Maserati Technical Bulletin

Date: 8/10/2018
Bulletin No: MTB-200917G
Supersedes: MTB-200917F
Section: Engine

Model Type: Quattroporte Automatic (M139) & GranTurismo (M145)
Model Year: 2007 to 2009
Subject: Addendum - Noise from variator

Figure 1 – Front camshaft bearing cap

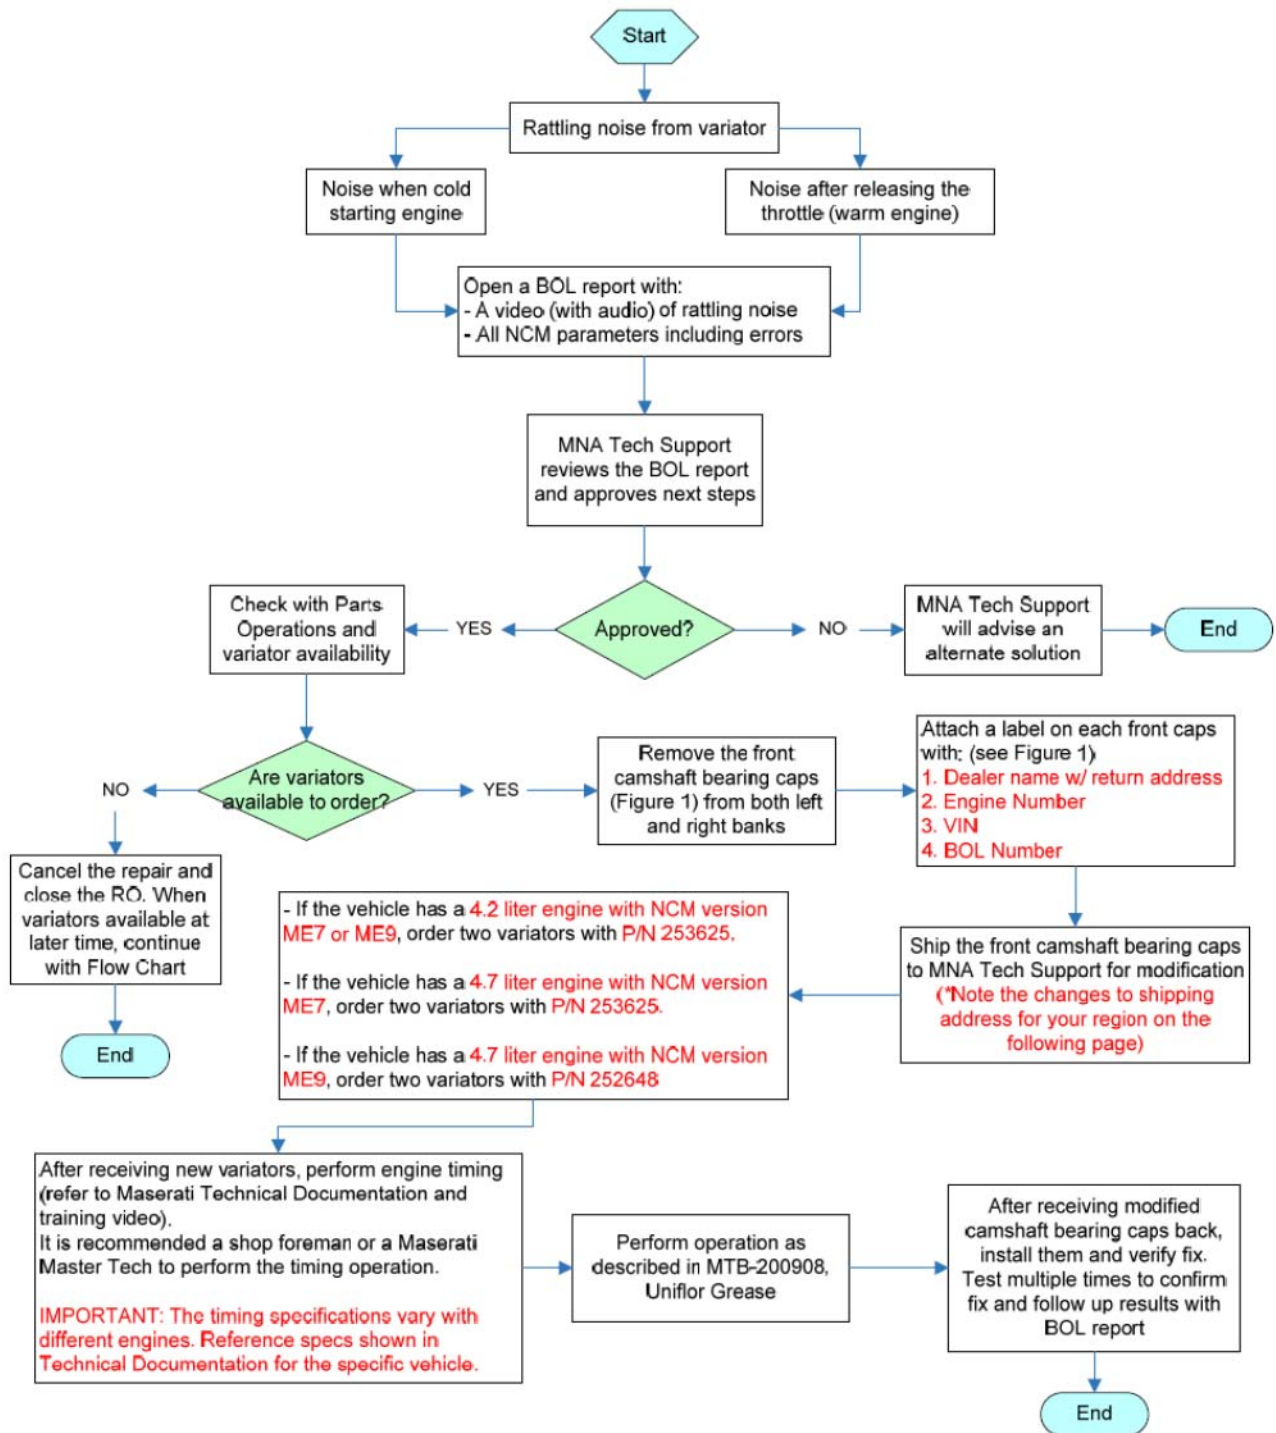
Note: The camshaft bearing caps are not available separately and can only be supplied with a complete head assembly. The front camshaft bearing caps will be modified by MNA and do not need to be replaced.
